Re: Luddenham Quarry Modification 5: Response to request for additional information

The letter provides a response to the NSW Department of Planning, Industry and Environment (DPIE)'s letter dated 10 February 2012 requesting additional information in response to matters raised in advice from government agencies in relation to *Luddenham Quarry Modification 5 Submissions Report* (EMM 2020a) (the 'MOD 5 Submissions Report'). The letter also provides a response to matters raised by DPIE including a record of stakeholder engagement carried out since the provision of the MOD 5 Submissions Report to DPIE.

Figure 2.2 Contribution to exceedances for cumulative 24-hour PM_{10} concentration – peak day

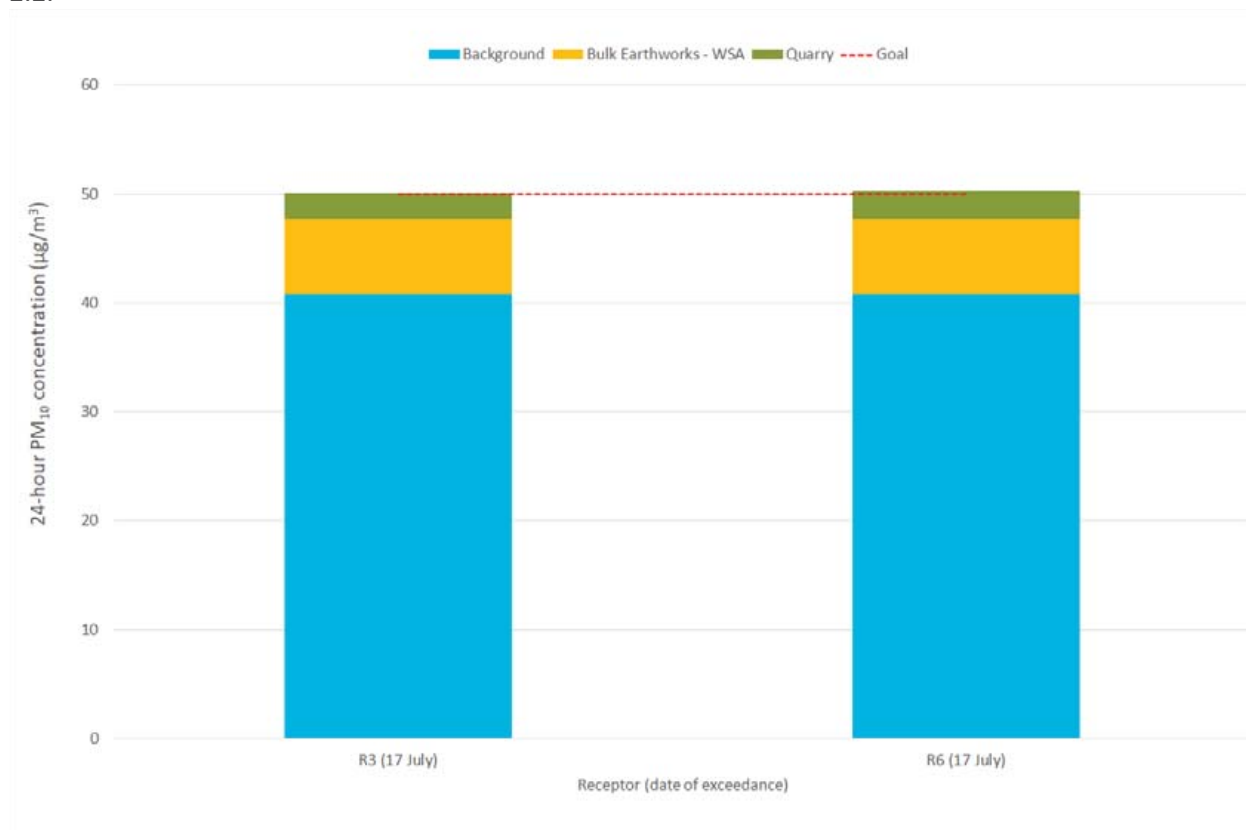
- Provide the predicted ground level concentrations for the scenario including peak daily truck movements, and source/premises contributions to predicted exceedances
- Provide the ground level concentrations for the revised modelling accounting for peak daily operations including accounting for the ARRC. This should include a contemporaneous assessment for the most impacted receptors (i.e. R3, R6, R1, C1).

The modelling predicts that there will be marginal exceedances ($50.1 \mu\text{g}/\text{m}^3$ for R3 and $50.2 \mu\text{g}/\text{m}^3$ for R6) of the 24-hour average PM_{10} criterion on one day of the year. No exceedances of the 24-hour average $\text{PM}_{2.5}$ criterion are predicted.

The relative source contributions to PM_{10} concentrations at R3 and R6 on this peak day are shown in Figure 2.2.

The MOD 5 Submission Report (Section 4.4.1) assessed the likelihood of the exceedances at R3 and R6 occurring. It found that there is a very low chance this will occur. Further discussion is provided below.

Figure 2.3 Revised water balance results – typical dry rainfall year

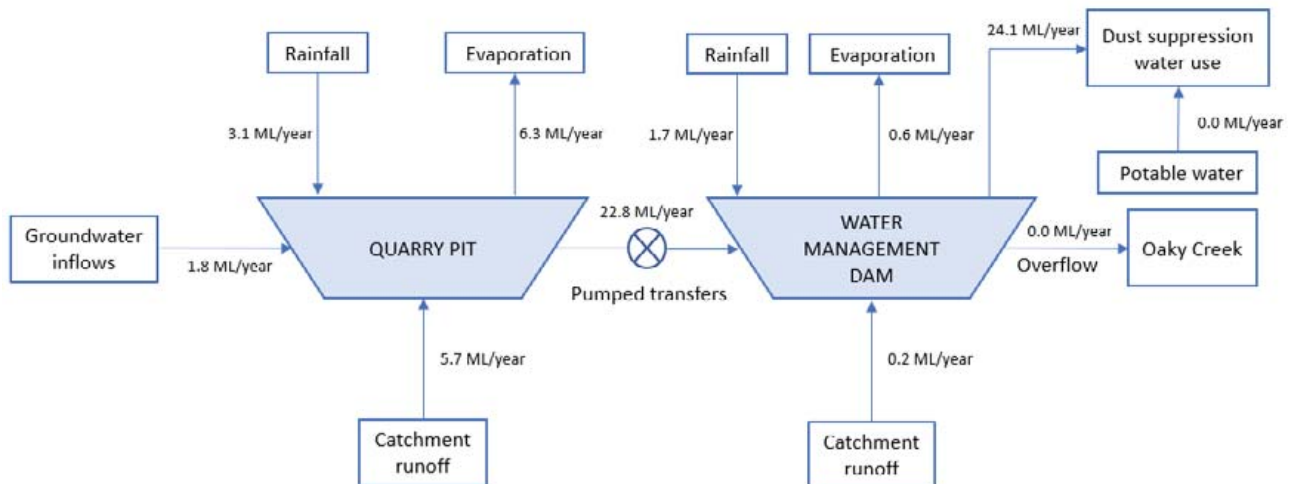
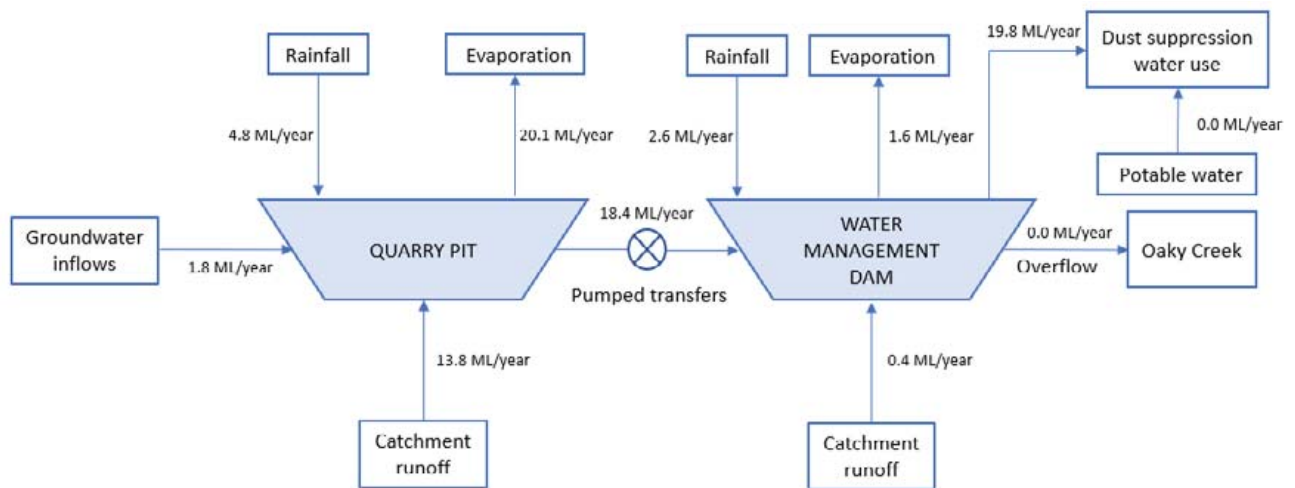
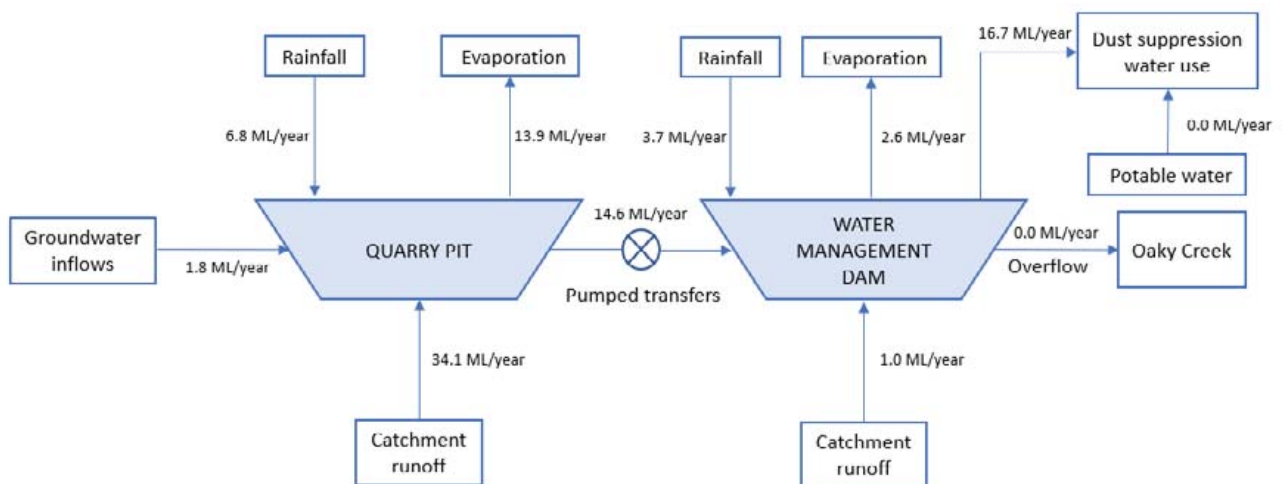
The Submissions Response indicates the applicant is in discussion with the adjoining neighbour WSA to pump the existing water within the Quarry Pit to a dam at WSA. This water would be reused for dust suppression. EPA notes that the operators of the WSA site would need to ensure that the water is of a suitable quality for the end use and that potential water pollution risks are appropriately managed. The Proponent has not confirmed that WSA will be able to accept the Quarry Pit water.

Due to the prolonged wet weather associated with the current La Nina, WSA has not required the water that has accumulated in the quarry void for dust suppression for WSA construction work as envisaged in the MOD 5 Submissions Report. This situation is unlikely to change in the short term. Discussions are ongoing with WSA with the view of providing WSA water in the future during quarry operations.

The distribution of water across the site, estimated by the revised water balance model for typical dry (10th percentile), median (50th percentile) and wet (90th percentile) rainfall years, is presented in Figure 2.3, Figure 2.4 and Figure 2.5 respectively.

The revised water balance results indicate that 100% of the demand for dust suppression can be supplied by harvested catchment runoff and the water currently stored within the quarry pit. No potable water use was modelled to be required in the revised water balance. The change in water management strategy to allow the storage of water within the quarry pit below 45 m AHD also resulted in a reduction in overflow frequency and volume predicted by the revised water balance.

Figure 2.6 EC with reference to pit depth

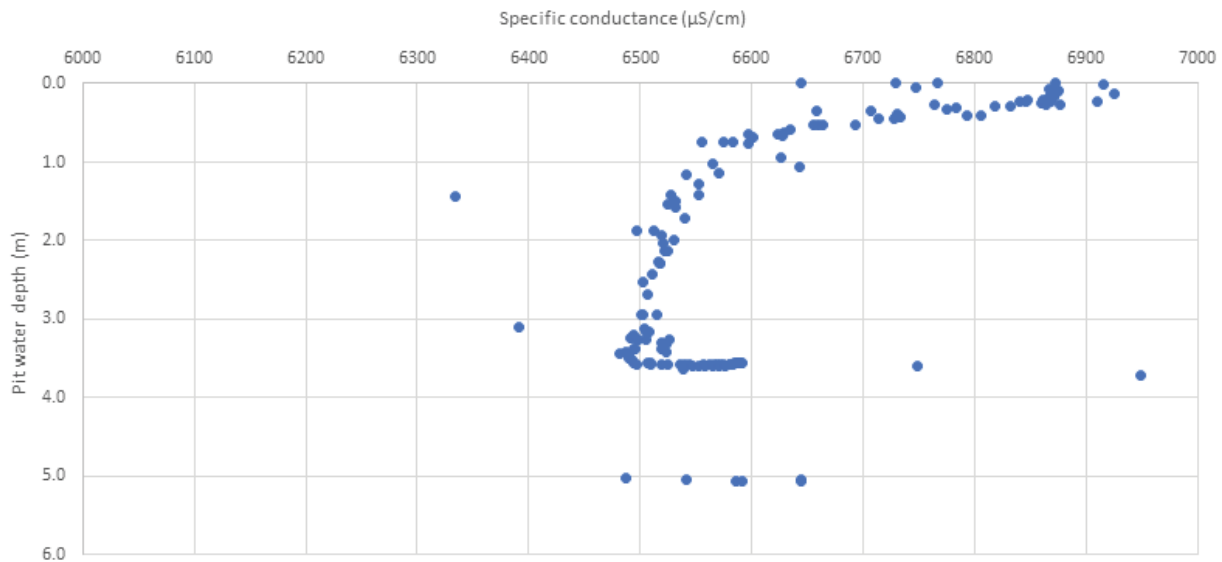
The Submissions Response did not provide any details of the sampling depth. Water quality within the Water Management Dam and the Quarry Pit could change with depth. Salt or thermal stratification could occur within the storages where lack of mixing at depth reduces oxygen concentrations and increases the likelihood of the release nutrients and metals previously bound to sediment when disturbed.

Measurements from all tests are shown in Figure 2.6. The deepest measurement was at 5.1 m where EC was ranged between 6,500 and 6,650 $\mu\text{S}/\text{cm}$. EC closer to the water surface tended to be slightly higher but in a similar range, between 6,550 and 6,950 $\mu\text{S}/\text{cm}$.

The results of the EC profiling indicate that there is no evidence that EC increases with water depth in the pit void. Conversely, the results suggest EC levels are slightly higher closer to the surface (ie within the first metre of water).
